1991 - 1992 Corvette: Service Bulletin: Starter Inoperative/Clicks/No Start

Model and Year: 1991-92 Corvette with Automatic Transmission

Source: Chevrolet Service Bulletin

Bulletin Number: 92-322-6D

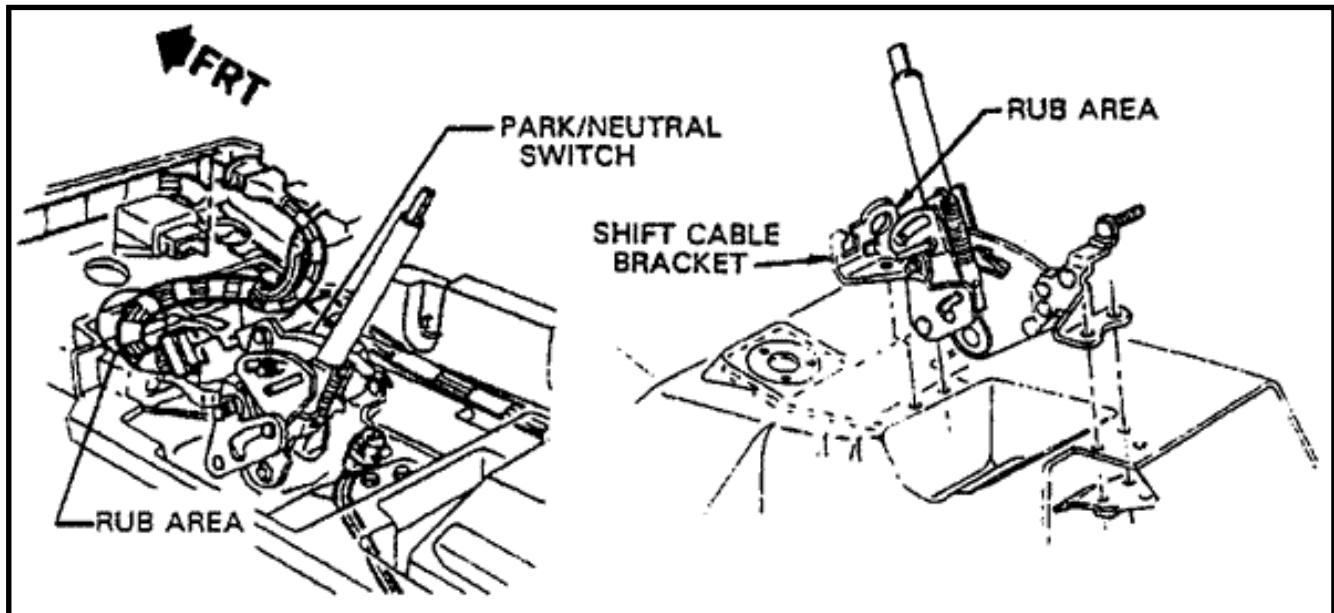
The starter may not operate (no sound), or may click (spins but fails to fully engage the flywheel), resulting in a no-start. This condition may also be intermittent. The condition appears to be similar to a low battery or a defective starter. There will be no codes set in the ECM or CCM, as there would be in a condition caused by the VATS system.

The 10 gauge purple wire from the park/neutral switch in the console is rubbing against the shift bracket (see illustration). This causes high resistance in the circuit, resulting in low voltage to the starter.

1. Disconnect negative battery cable.
2. Remove console trim plate as shown in the 1992 Y Car Service Manual, page 8C-11.
3. Check the wire harness in the area shown in the illustration for signs of rubbing.
Correct as necessary.

4. Reroute the harness to the right of the bracket, about 50 mm (2 inches) over, and under the plastic portion of the console. Secure as needed to insure that the harness cannot contact the bracket
